# **2006 - 2009 Cadillac XLR: Service Bulletin: #PI0299: Harsh Shifts After Replacement of 1-2-3-4 / 3-5-R Clutch Housing**

## **#PI0299: Harsh Shifts After Replacement of 1-2-3-4 / 3-5-R Clutch Housing - (Nov 16, 2010)**

**Models:** 2006 - 2009 Cadillac  
XLR  
2006-2011 Cadillac STS  
2007-2011 Cadillac  
Escalade Models  
2008-2011 Cadillac CTS  
2006-2011 Chevrolet  
Corvette  
2007-2011 Chevrolet  
Silverado  
2008-2011 Chevrolet  
Suburban  
2009-2011 Chevrolet  
Avalanche, Tahoe  
2010-2011 Chevrolet  
Camaro, Express  
2007-2011 GMC Sierra,  
Yukon Denali, Yukon  
Denali XL  
2008-2011 GMC Yukon  
XL  
2009-2011 GMC Yukon

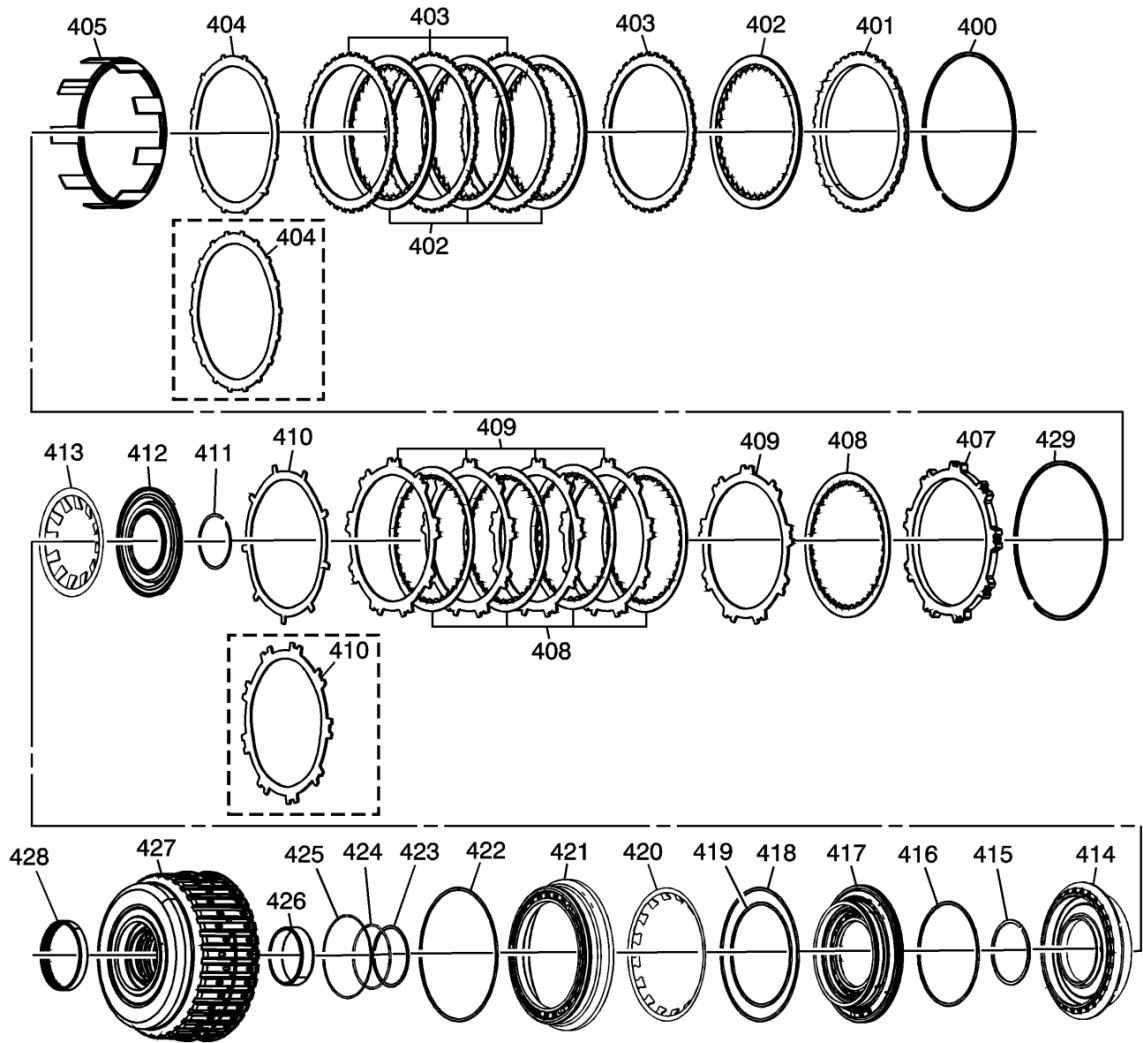
Some customers may comment on harsh shifts after replacement of the 1-2-3-4 / 3-5-R clutch housing (427).

This condition may be caused if the 1-2-3-4 / 3-5-R bearing (428) is not installed into the housing (427). The 1-2-3-4 / 3-5-R clutch housing is currently serviced through parts without this bearing installed and failure to order and install this bearing may result in harsh shifts. Plans are being implemented to service this housing as a kit that will include the bearing.

**Note:** The parts catalog calls out to order the bearing when the housing is also replaced.
